Staff Report

To: BOZAR
From: Jessie Earley, Town Planner III
Meeting Date: BOZAR, January 28, 2025
RE: (320 and 320 ½ Gothic Avenue), Final Review

PROJECT TITLE: Agosto 2023 Management Trust (320 and 320 ½ Gothic Avenue)

SUMMARY: Consideration of the application of **Agosto 2023 Management Trust** to site a new single-family residence and accessory dwelling to be located at 320 and 320 ½ Gothic Avenue, Parcel 2, Booth Minor Subdivision, Block 15 in the R1 zone.

1/28/2025 BOZAR: revised site plan

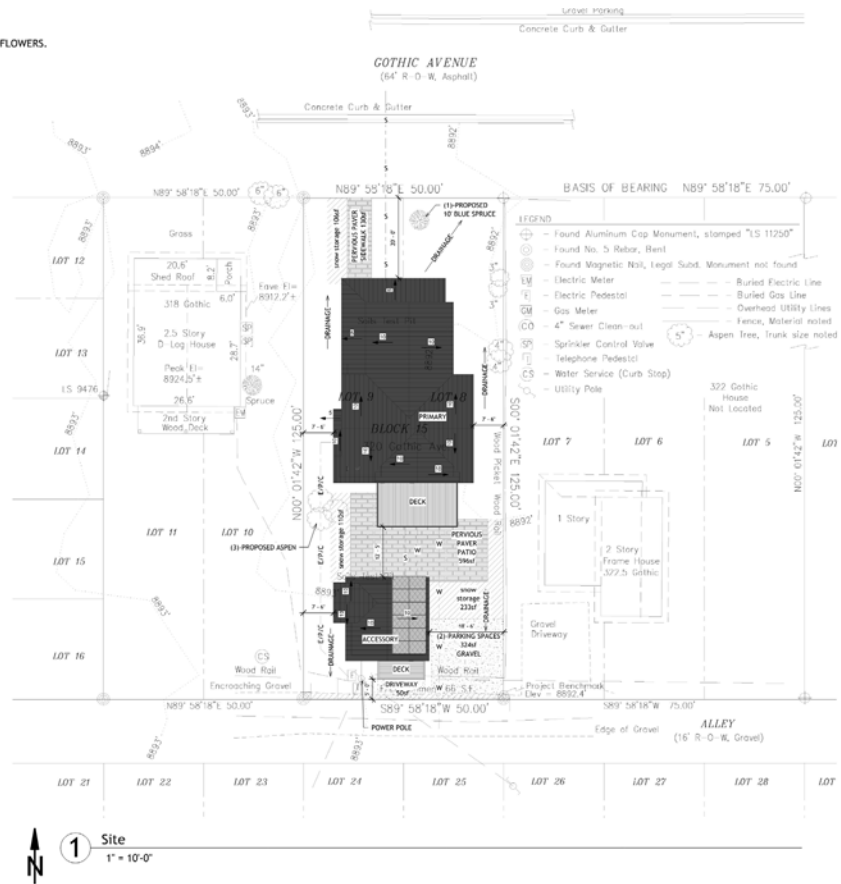
GL	Staff Analysis	DRC Recommendation
Topography	Topography has been provided. This lot slopes up from north to south from 8892' to 8893'. Grade for the purposes of measuring FAR would be 8892' for the primary building and 8893' for the ADU. Grade is not averaged for this lot. This has been updated on the elevations.

2.8 Drainage	Drainage has now been noted on the site plan. It shows drainage to the north and south.	Provide information on the site plan
Easements	NA	NA

2.19 New trees	There is one blue spruce noted for the north (front). An additional tree must be added to meet this provision. There is a cluster of proposed aspen trees on the southwest corner of the building.	Provide information on site plan

Utilities	Utility lines have been shown for wet and dry utilities. Additional information was added regarding the connections with the ADU. Adjacent rights of way have been included to-scale.	Support
2.7 Snow Storage	Snow storage is provided onsite and meets the 33% requirement of the areas to be plowed. These areas also correspond with areas to be plowed. Support.	Support

- Expanded utility connections
- Surface drainage indicators
- Removed gravel note on NW corner

- 3 proposed aspens
- 1 proposed blue spruce
- Gravel/pervious paver callouts
- Cooktop added for studio
- Exterior lights added at ADU exterior

1 North
1/4" = 1'-0"

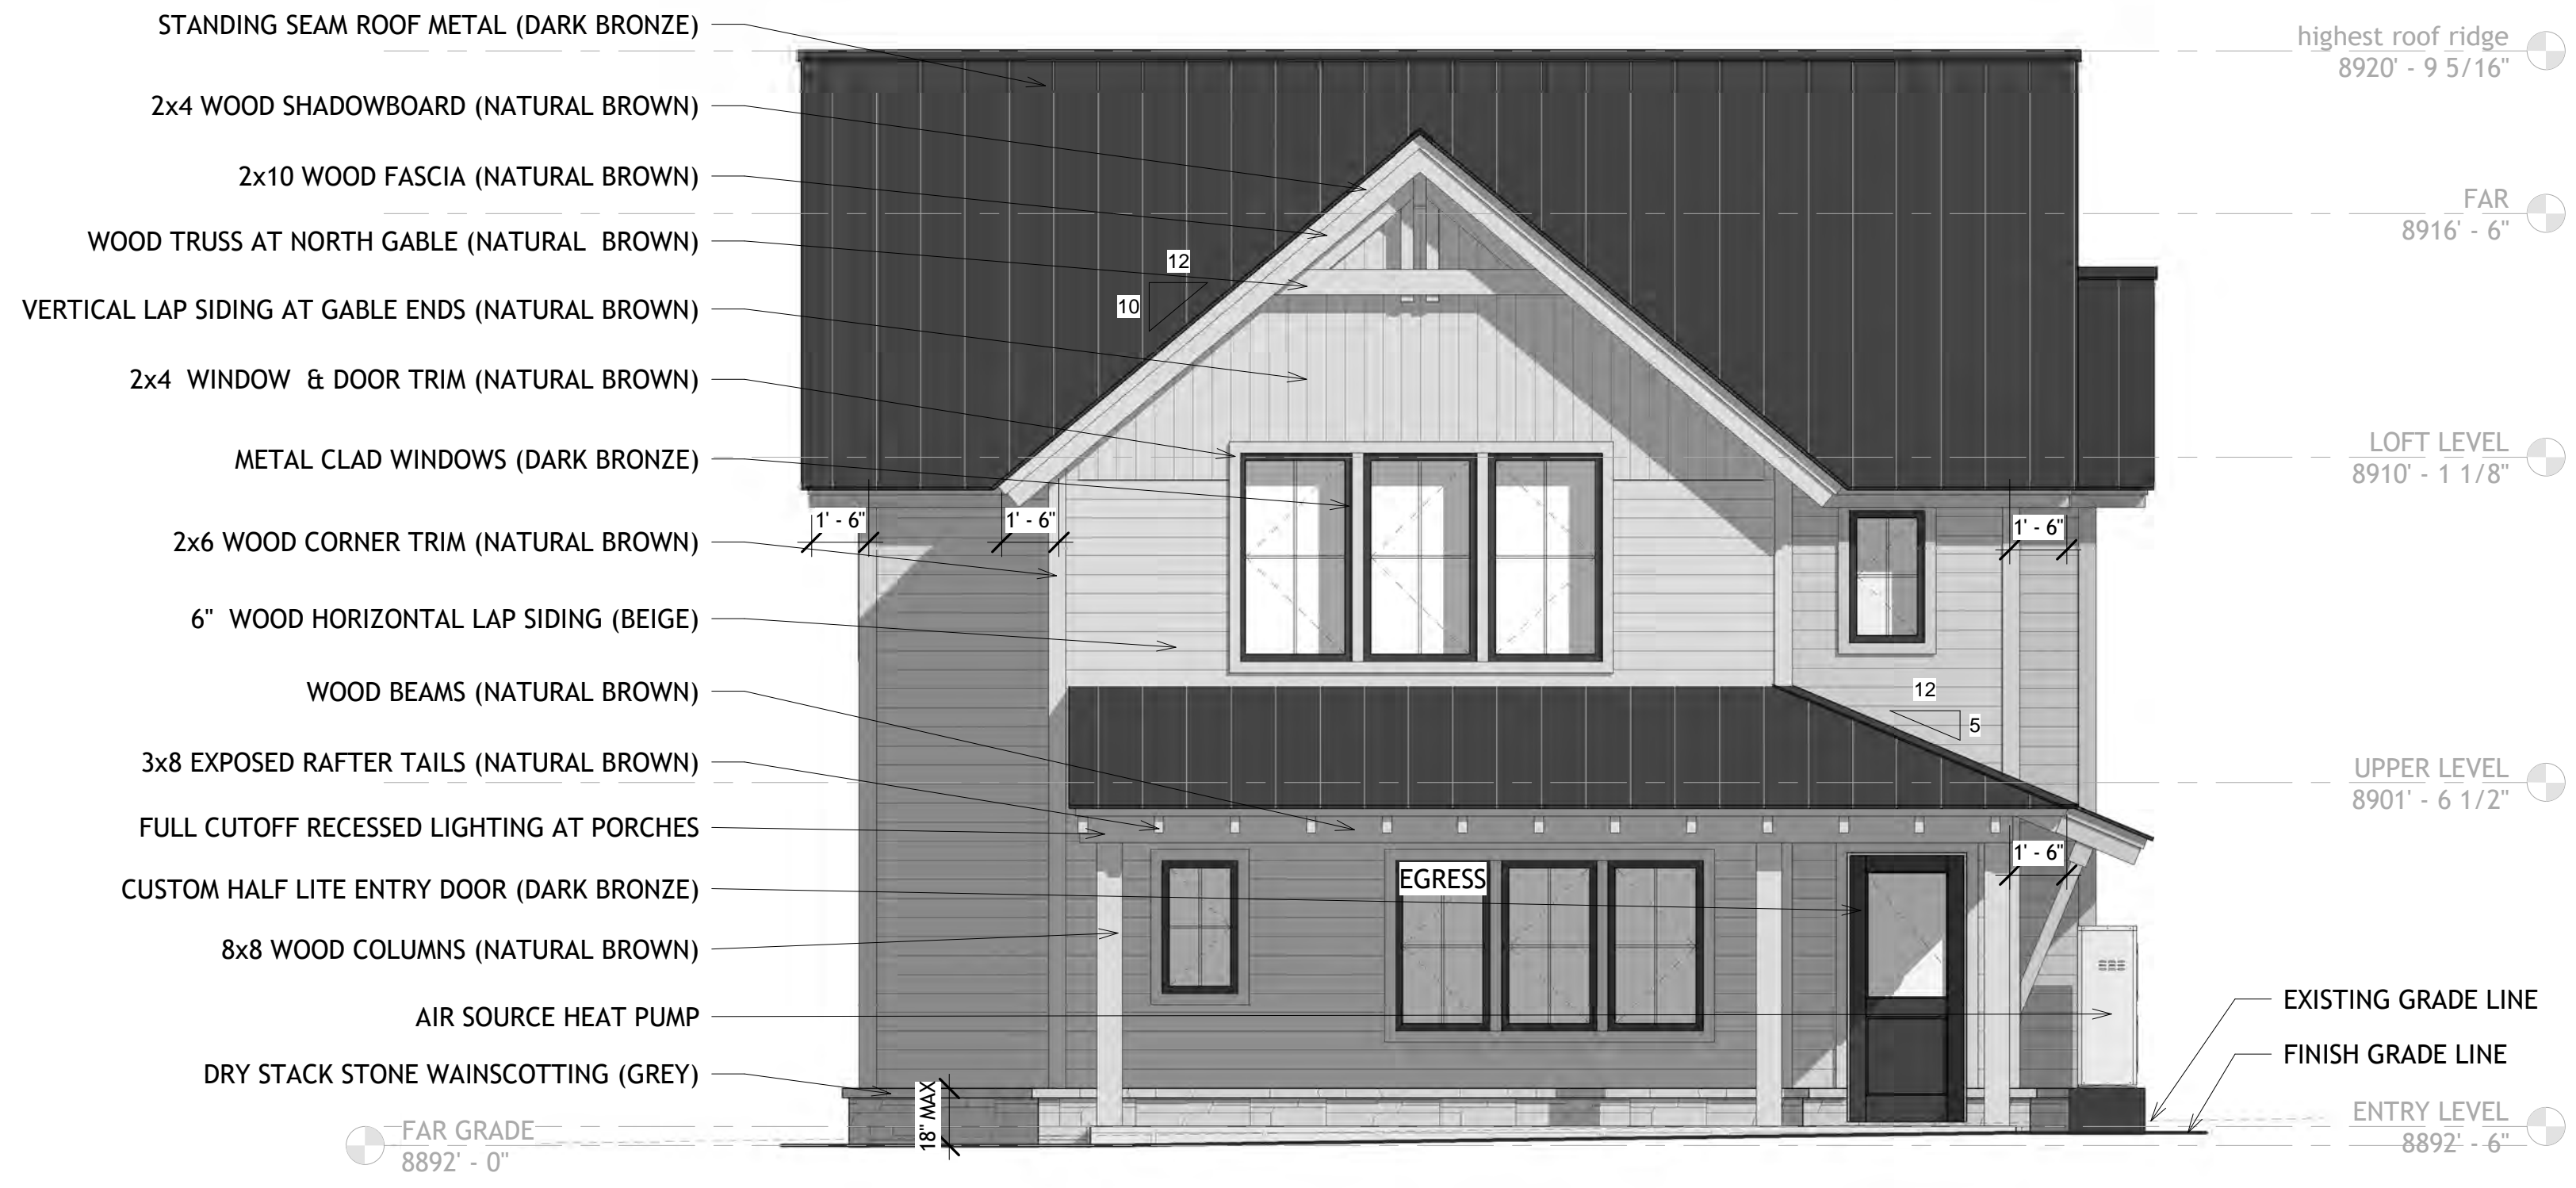
GL	Staff Analysis	DRC Recommendation
4.53 Window to wall ratio	<p>Window to wall ratios along the front (south) elevation proposes 115.93 sf of glazing/639.3 sf wall space, which is 18.1 % window to wall. This is relational to other approvals.</p> <p>The first floor proposes a three pack, single window and door glazing (46.66 sf). There is a three pack, and a single window on the second floor (55.03 sf), which appears to conflict with the intents of 4.53 b.</p> <p>On the west elevation, there are two, two packs and three single windows on the first floor and four single windows and a two pack on the second floor. There is one window in the gable.</p> <p>On the east elevation, there are two, two packs and three single windows on the first floor. The second floor proposes one three pack and two, two packs. There is a single window in the gable.</p> <p>Window to wall ratios along the rear (south) elevation proposes 137.56 sf of glazing/670.62 sf wall space, which is 20.5 % window to wall. This is relational to other approvals.</p> <p>The south elevation proposes a two pack, three pack and door glazing on the first floor. There are two, two packs and door glazing on the second floor and a two pack of windows in the gable.</p>	<p>12/9 DRC: Members expressed some concern regarding the first floor to Second floor ratio of windows, as it was top heavy. The second floor windows were reduced by 6", which reduced the second floor sf slightly.</p> <p>1/13 DRC: Members supported, as proposed.</p>

- Lowered subordinate roof at loft level creating a gable on the south elevation.
- Broke up the dominant roof overhang at this new south gable.
- Upper-level windows at North elevation got 6" shorter.
- Removed door at Flex room to create an Office nook.
- Changed to standing seam roof at the ADU.
